Your Ref: SSD 8677

ALTERATIONS AND ADDITIONS TO FAIRVALE HIGH SCHOOL 1 THORNEY ROAD, FAIRFIELD WEST (SSD 8677) NOTICE OF EXHIBITION

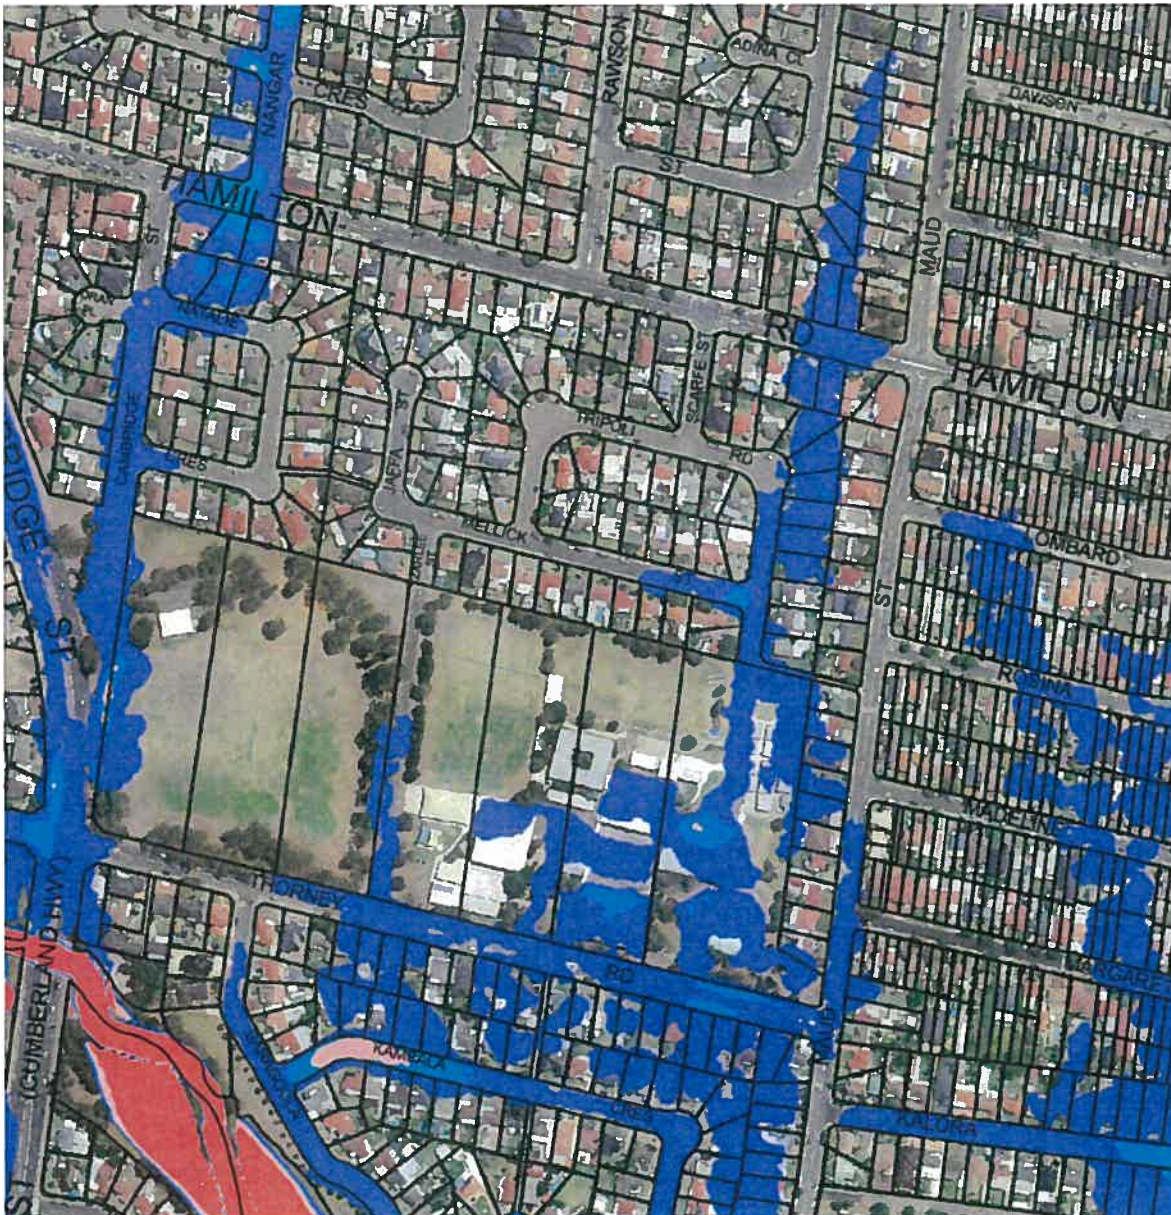
As can be seen in the map above, a large portion of the site, including the location of proposed works is within the Medium and Low Flood Risk precincts. A map showing depth of water in the 100 year ARI event is included below.

Council Officers recommendation: It is critical that the proponent considers this information and the impact this flooding may have on the proposed works and existing surrounding development. A flood risk assessment, flood risk management plan and hydraulic engineering report should accompany the application as the adoption of the modelling is imminent. Please ensure that flood sensitive design techniques are addressed as part of this proposal.
